Replace Step 6 instructions with the following:

6

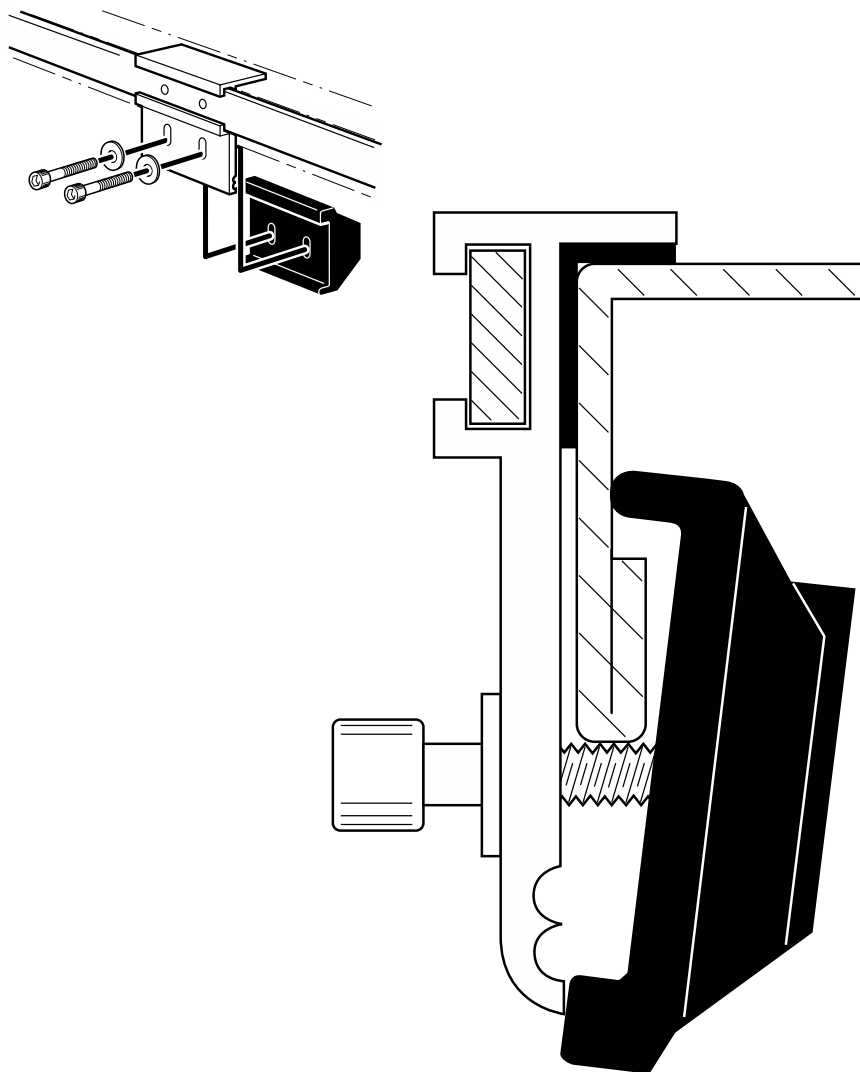
Clearance between bracket bolt and side wall rim the round bead does not fit in the bracket grooves. Invert the clamp so that the square bead contacts the lower lip of the bracket. It will rest securely on that edge.

Attach clamp to each side bracket with two clamp bolts.

Do not tighten at this step.
